SEAS DEADLINE 6 RESPONSE to APPLICANTS's SUBMISSIONS
SINCE DEADLINE 5, ISH3, Action Points and ExQ3
LANDSCAPE & VISUAL and CULTURAL HERITAGE

PINS Ref: EN020026
DEADLINE 6: APRIL 13, 2026

EN020026 SEA LINK DCO – DL6: RESPONSE BY NICHOLAS BRIDGES

ZTV ANALYSIS – IP ref FA62B0DA

Figure 16. Sea Link EN020026-000343-6.4.2.1 ES Figures Suffolk Landscape and Visual Part 7 of 7, page 6
 CUMULATIVE SCHEMES (MAJOR PROJECTS) SCREENED ZONE OF THEORETICAL VISIBILITY – SIZEWELL C

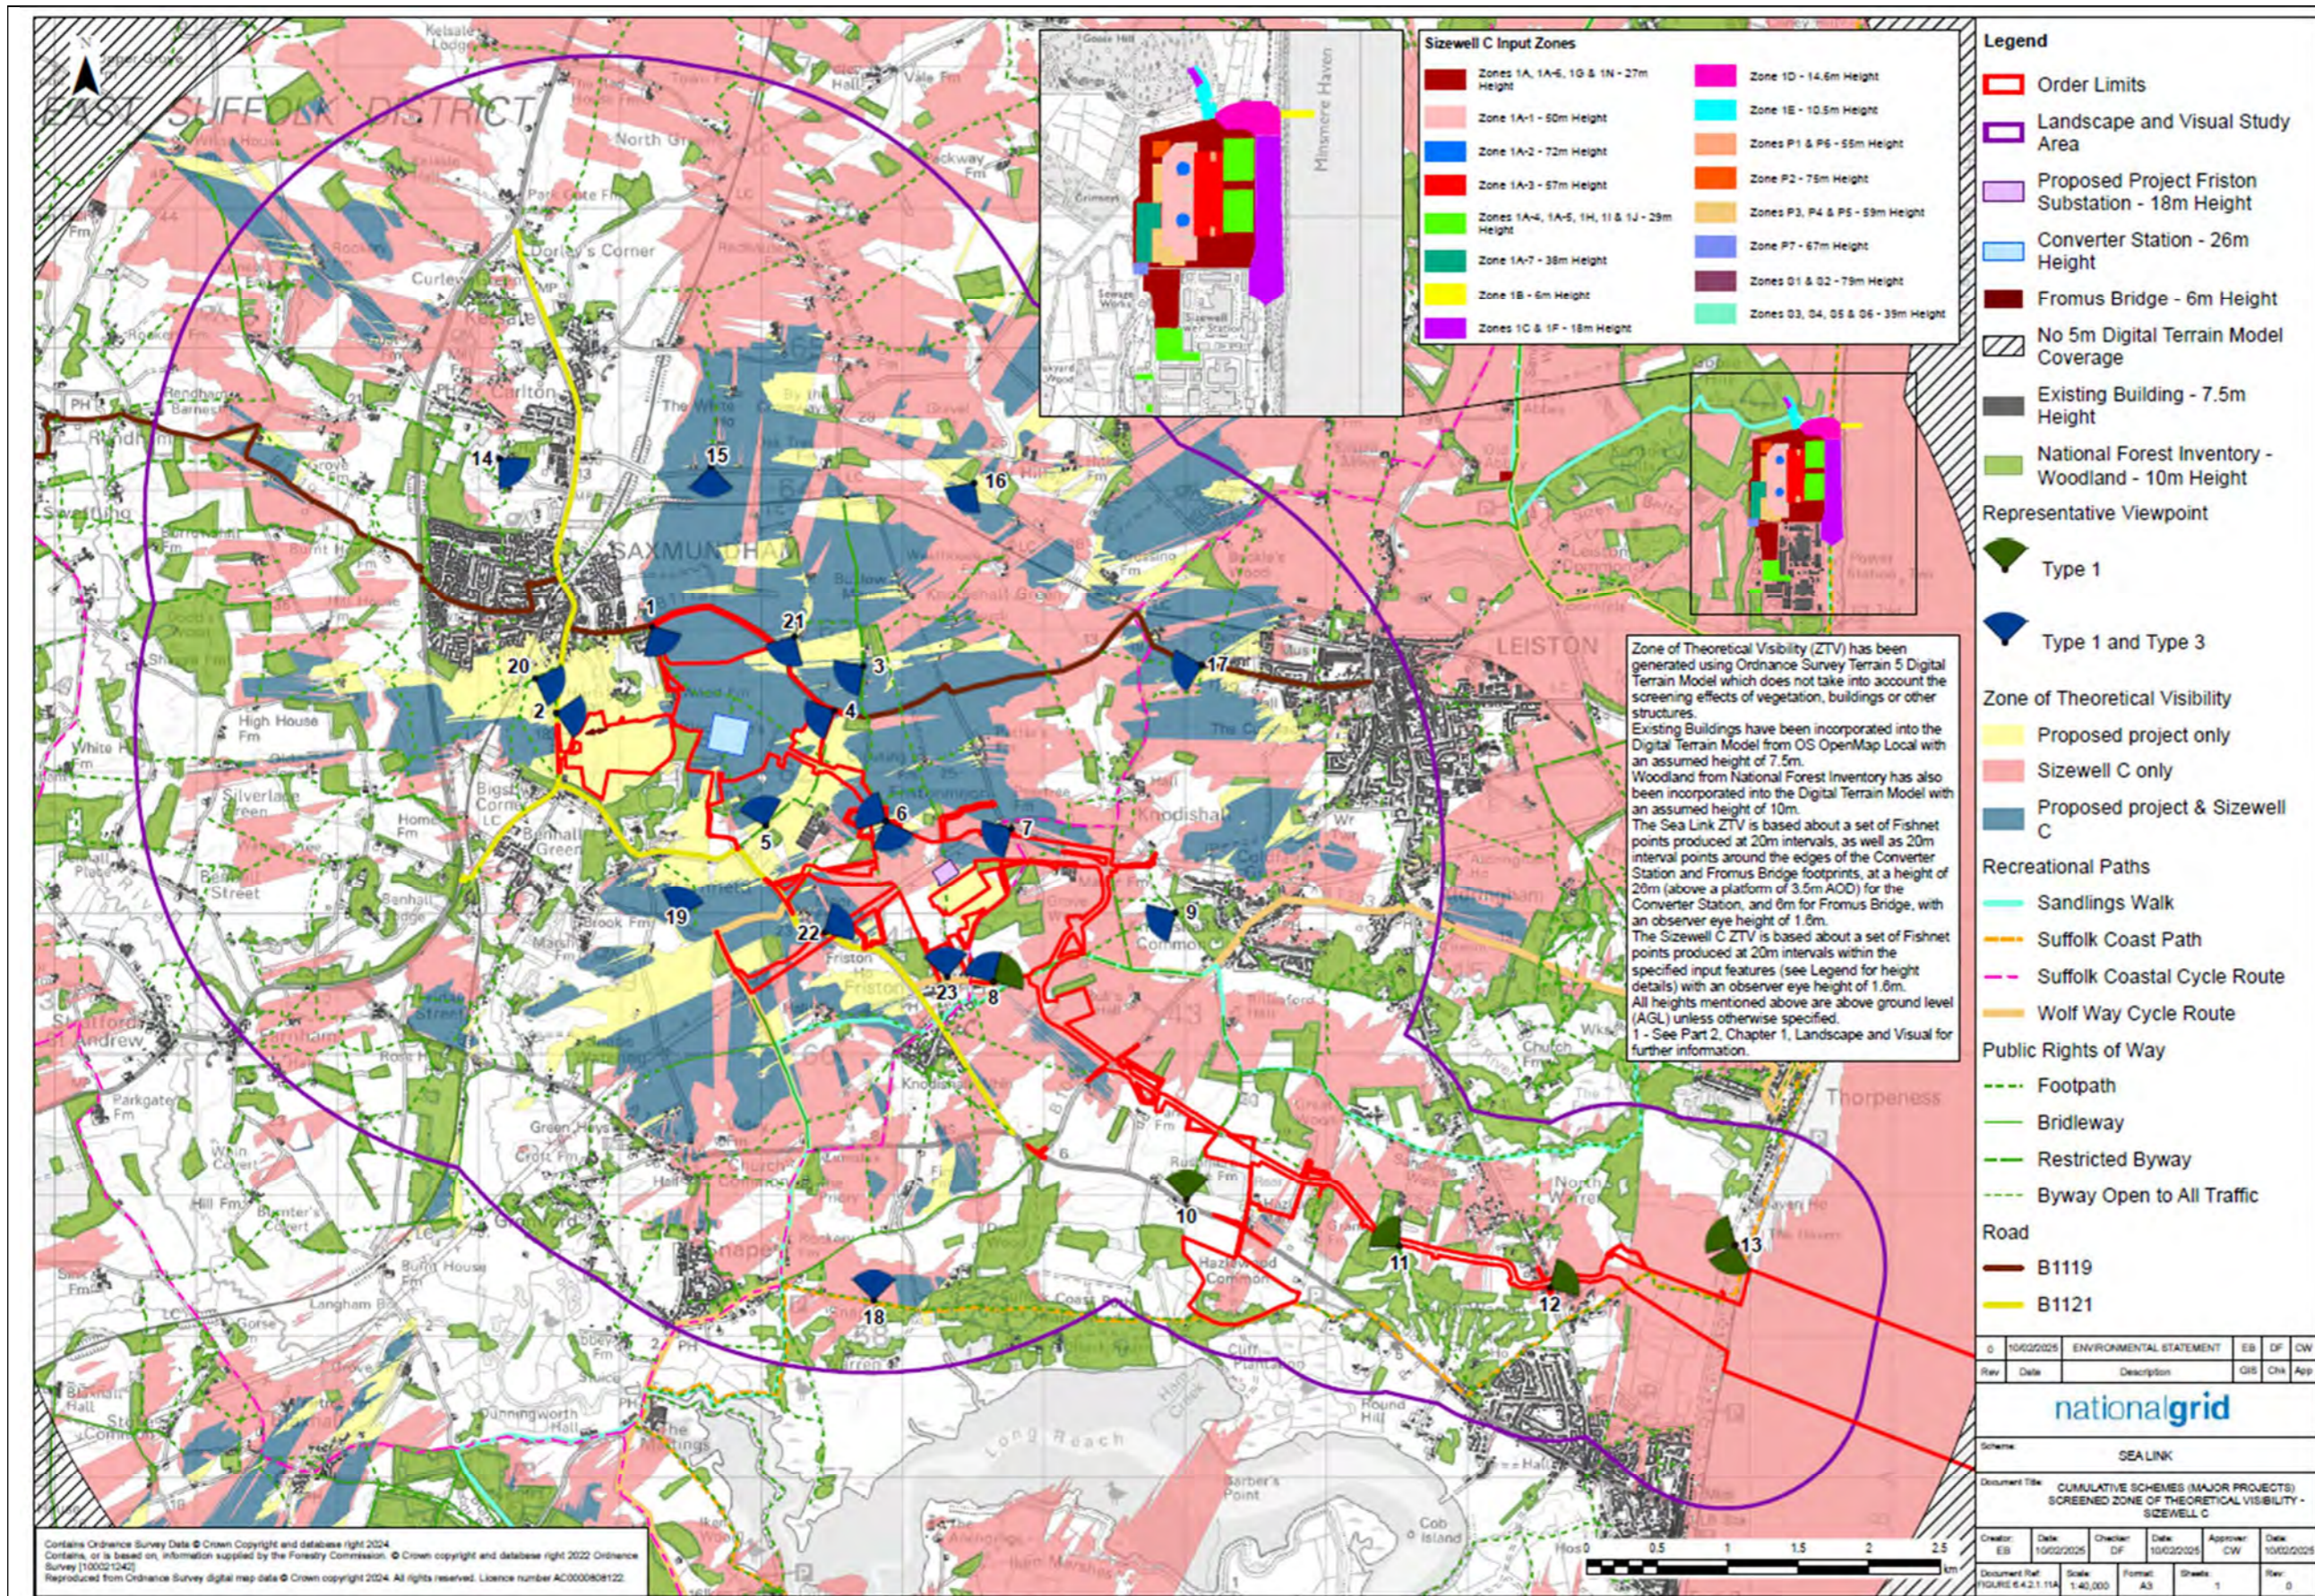
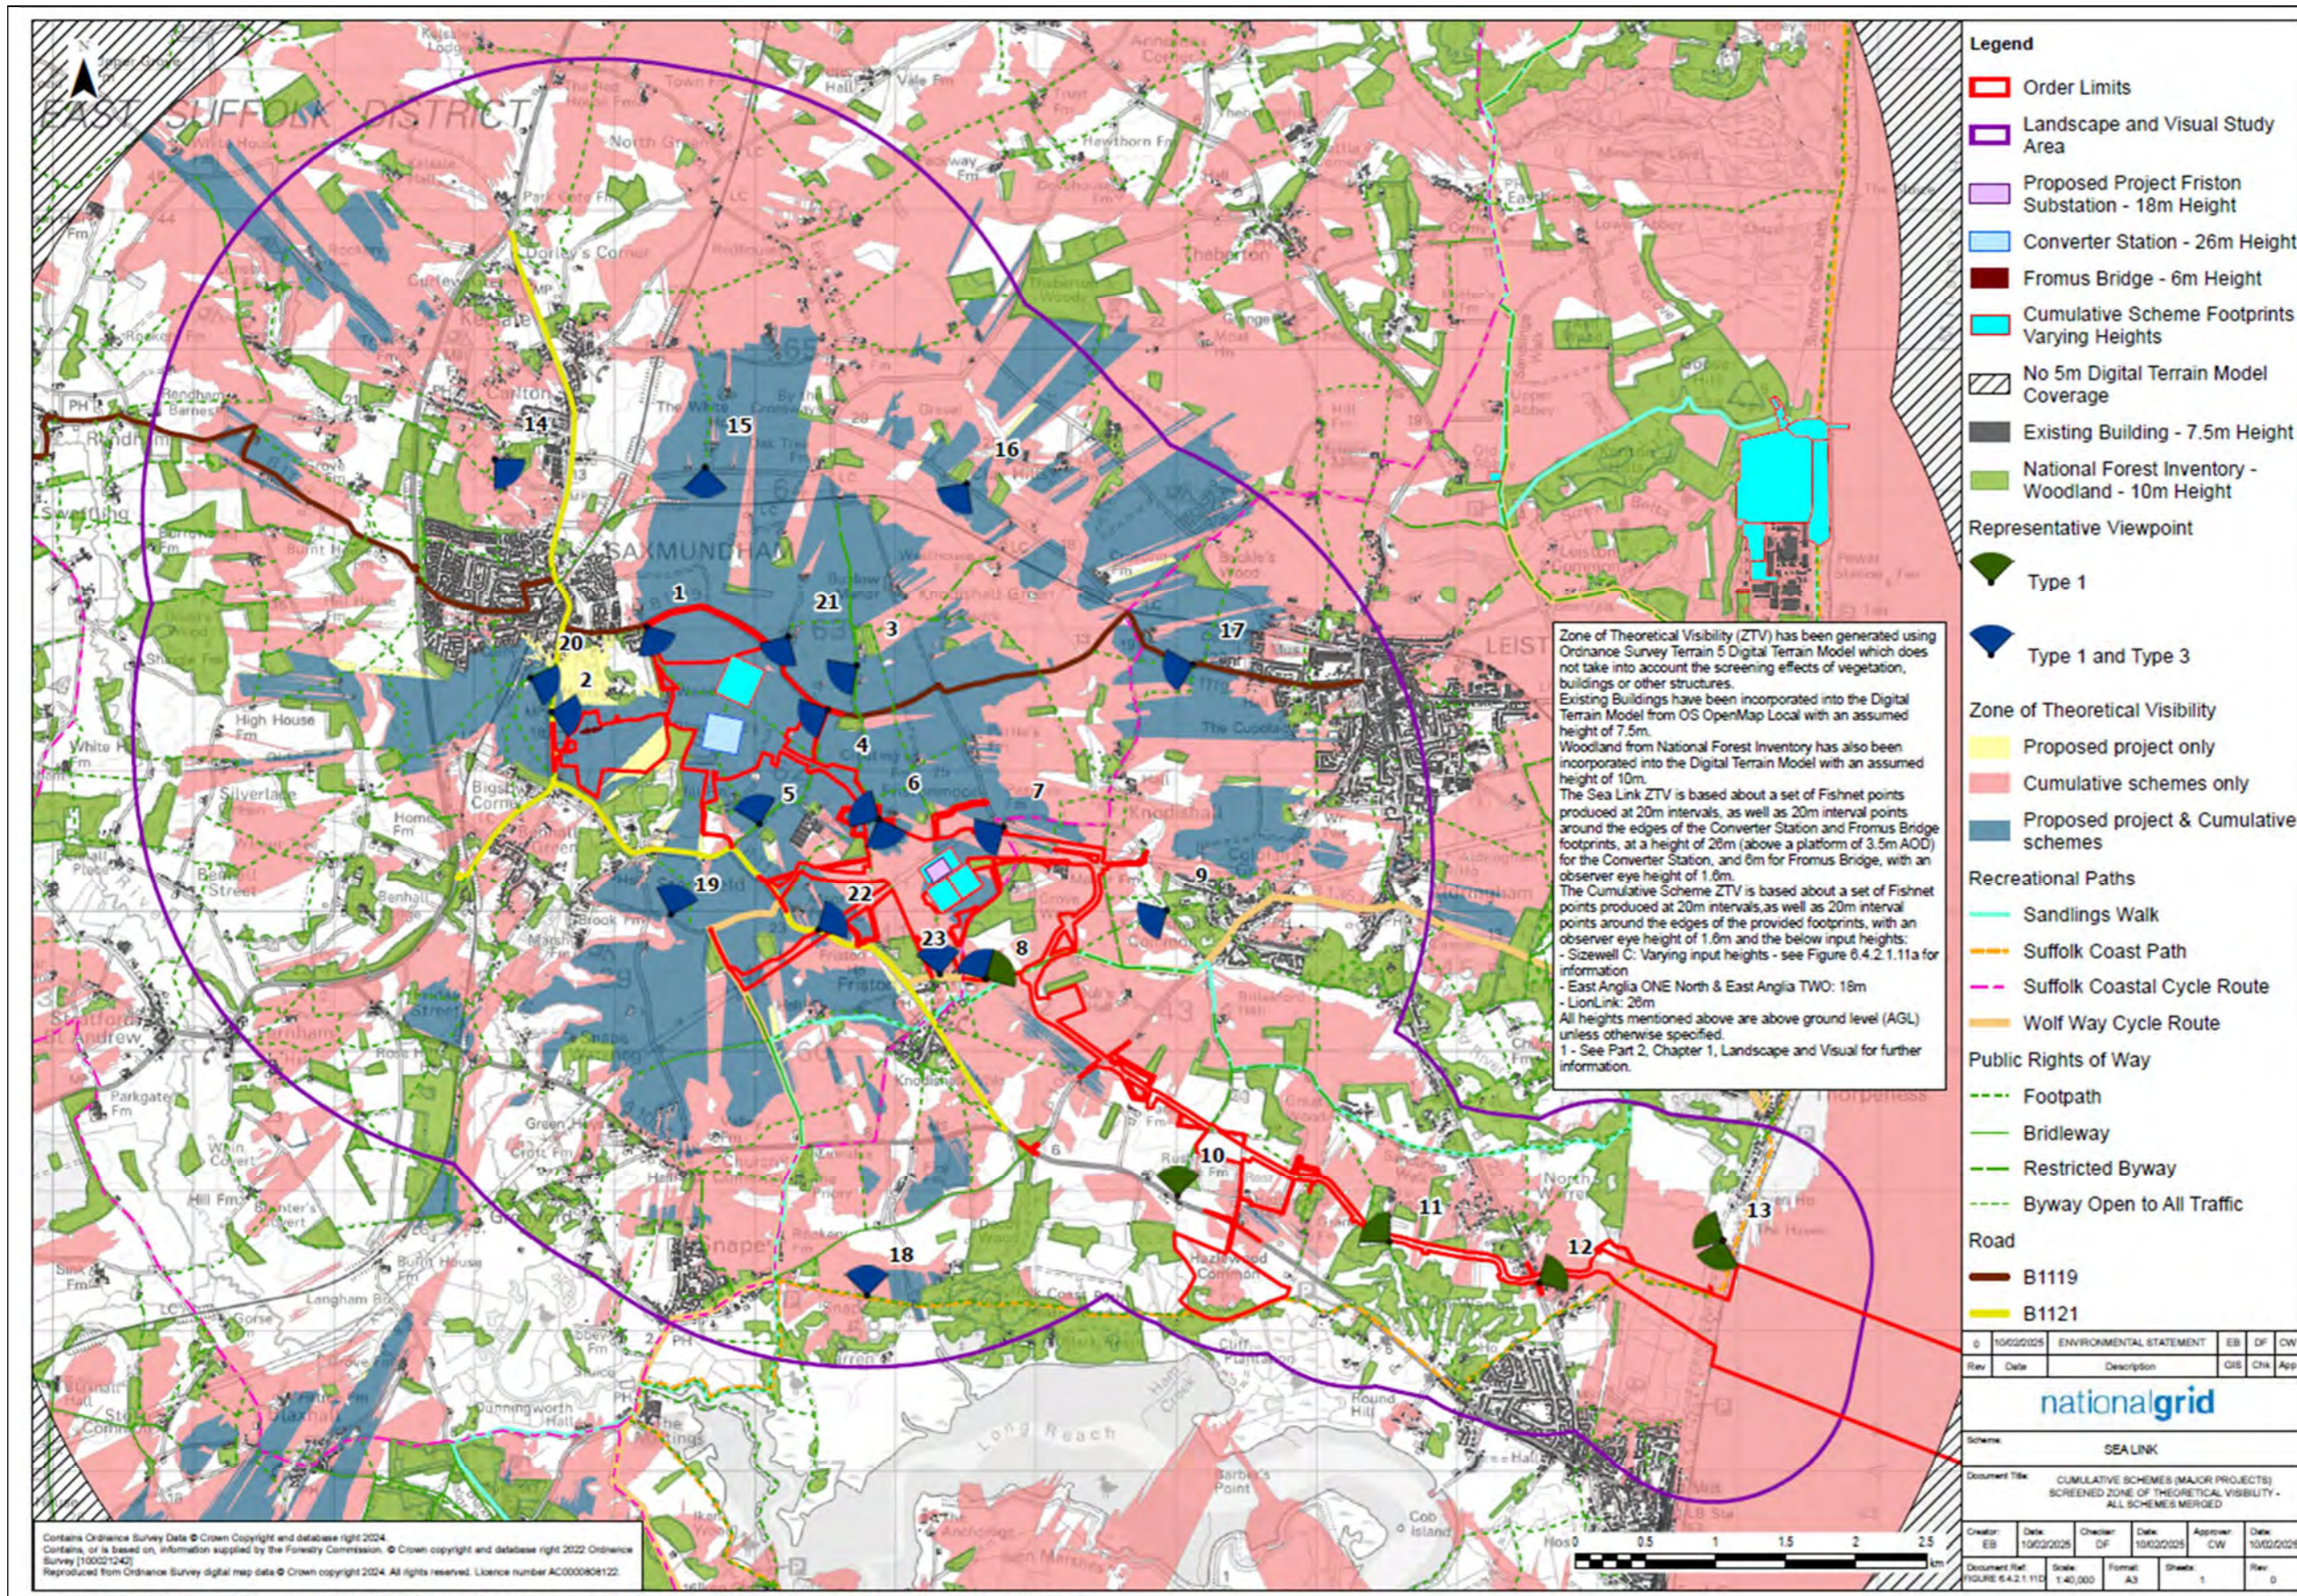
2.10. The 'shadow' patterns illustrate the 'shading' effects of woodland and buildings. The ZTV plans of the same proposed volumetric parameters (**Figures 12 to 17** below) show far less visibility than its PEIR ZTV plans. The accompanying textual details of the model's constraints are exactly the same (see the schedule below).

2.11. The **first question** is: why are the PEIR and DCO plans so completely different? Were the heights in the model changed? Were the shadowing criteria altered? Which is correct? If the DCO is correct, were the EA1N and EA2 ZTVs incorrect? These are simple technical points which can be explained easily.

- 3.1. The submitted DCO ZTV plans should be reviewed for their accuracy.
- 3.2. If they are correct, the applicant must explain why the PEIR was so different
